RESPONSE TO DEC REVIEW FINDINGS

Addendum No. 2: Recharge Basin Design and Operation for Intermittent Wetland Benefits

July 1, 2020

Figure 9. Environmental Defense Fund Guide on Building Multi-Benefit Basins

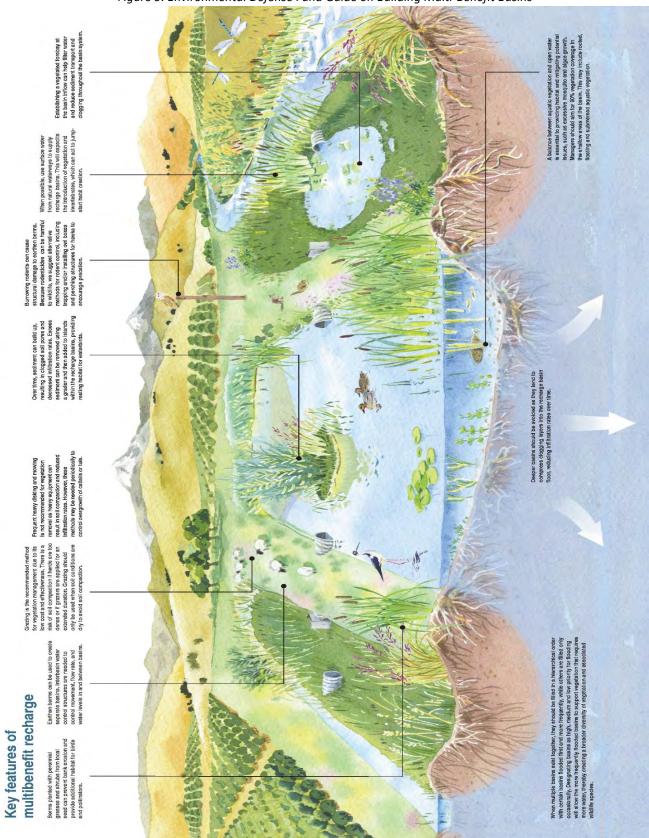
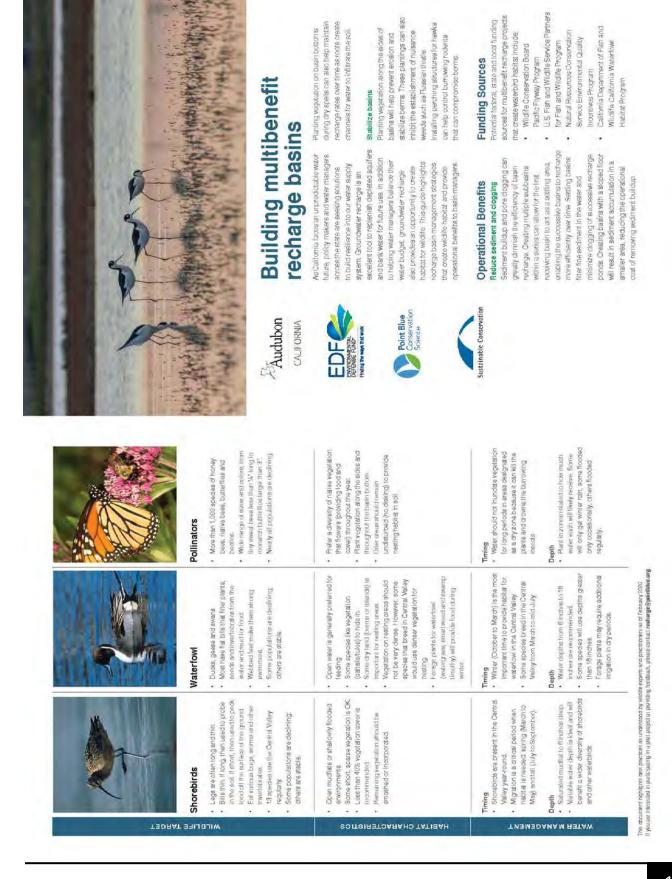
- a. As currently designed the recharge basins may not meet the requirements for classification as an intermittent wetland.
- b. Determine requirements for creation of intermittent wetlands, and update design and cost estimate to include these features.

Design Criteria #4: Establish habitat for birds during recharge operations – RRBWSD has been working with the Environmental Defense Fund (EDF) in an effort to construct and operate recharge facilities that have multi-benefits, including intermittent wetlands and bird habitat. EDF partnered with Point Blue Conservation Science, Audubon California and Sustainable Conservation to develop a guide on how to build this kind of preferred recharge basin that provides operational benefits to basin management while also creating valuable water bird habitat. Figure 9, included at the end of this addendum, is the guide prepared by EDF. This guide describes the wildlife benefits associated with the multi-uses of recharge basins as intermittent wetlands.
